## **Re: Hertford Theatre, Hertford – Planning Condition 4**

This is a letter from Temple for GPF Lewis which documents the specification for a selection of boxes targeting bats, birds and bees for the development at Hertford theatre.

Figure 1: Bat, Bird and Bee Box Plan (Fabrik, 2023d)

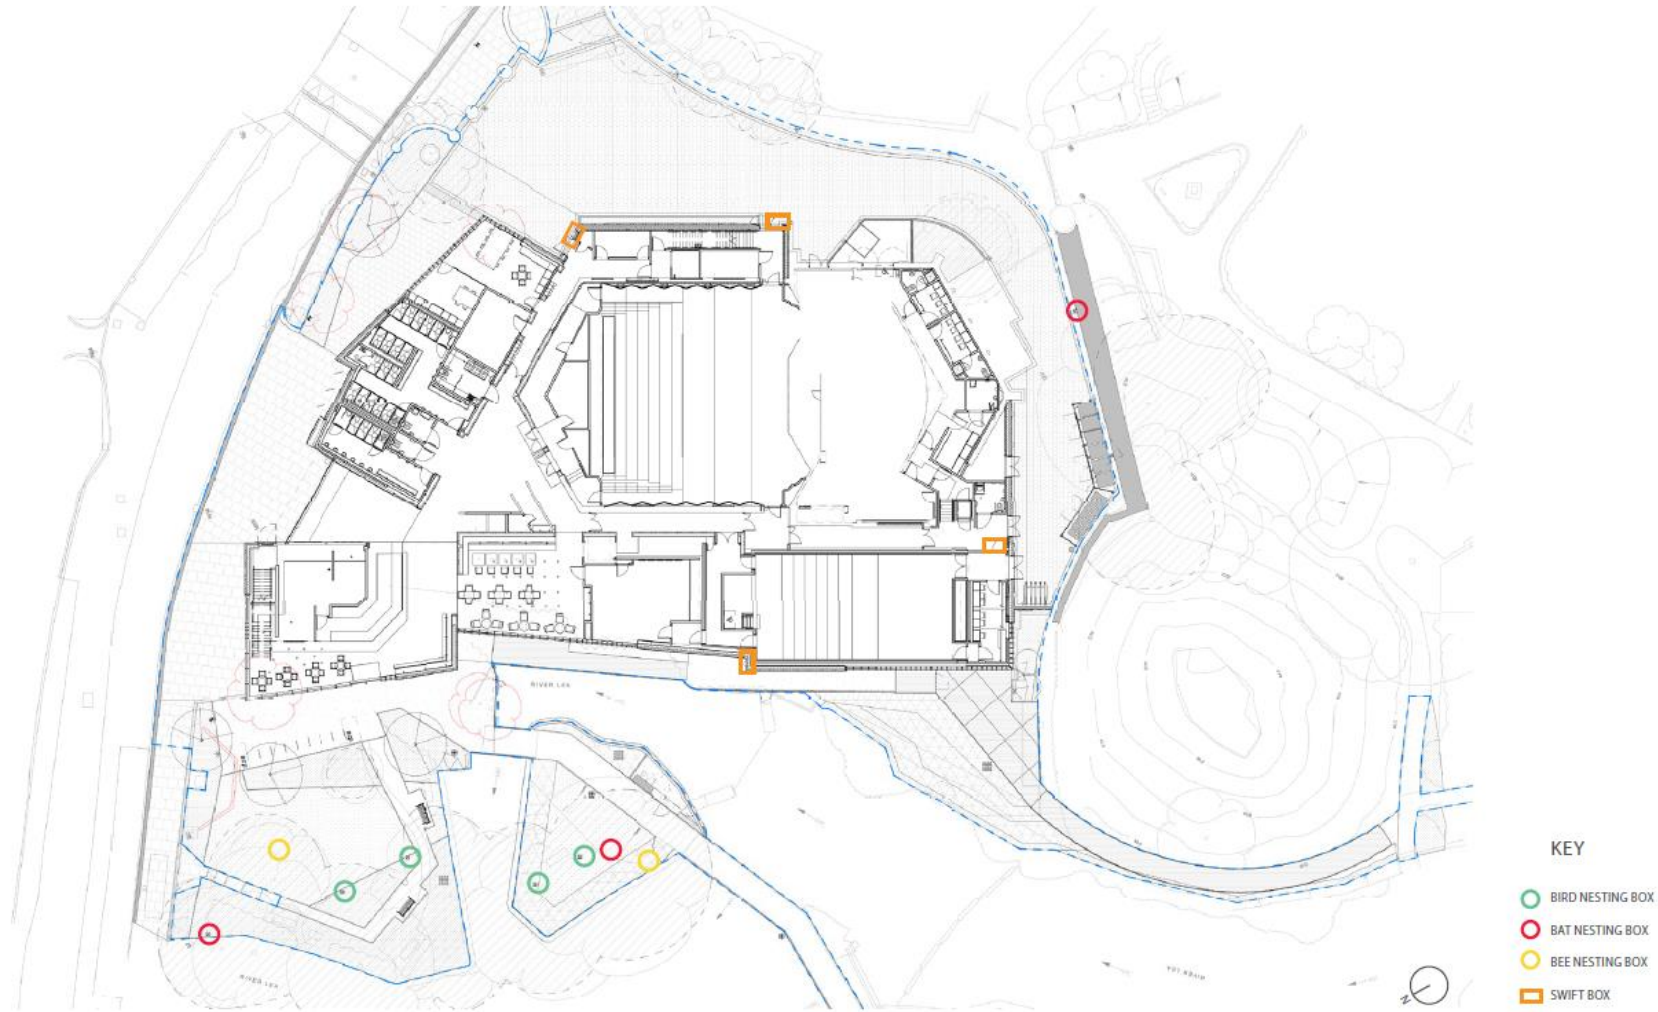
Originally, one bat box was proposed to be installed on a tree in the west and two on the wall in the south of the site. Upon review of the bat box locations and the lighting study (Pritchard Themis, 2023), Temple advised that one of the bat boxes be moved from the wall in the south, to a tree in the west subject to lower lux levels and in a location with connectivity to the river and proposed meadow lawn which are suitable for foraging and commuting, to increase the likelihood of it being used. This has been amended, as shown in Figure 1, Appendix 1.

Temple have reviewed the proposed location, number and specification of the bat, bird and bee boxes (Fabrik, 2023d), along with landscape plans (Fabrik, 2023a-c) and lighting plans (Pritchard Themis, 2023, Temple 2024a). We did not provide advice or comment on the swift boxes as these were already built into the new building. However, we can confirm all other boxes meet recommended specifications and numbers and are in suitable locations. This letter should be read in conjunction with the lighting review letter and the Landscape and Ecological Management Plan (Temple, 2024a, b).
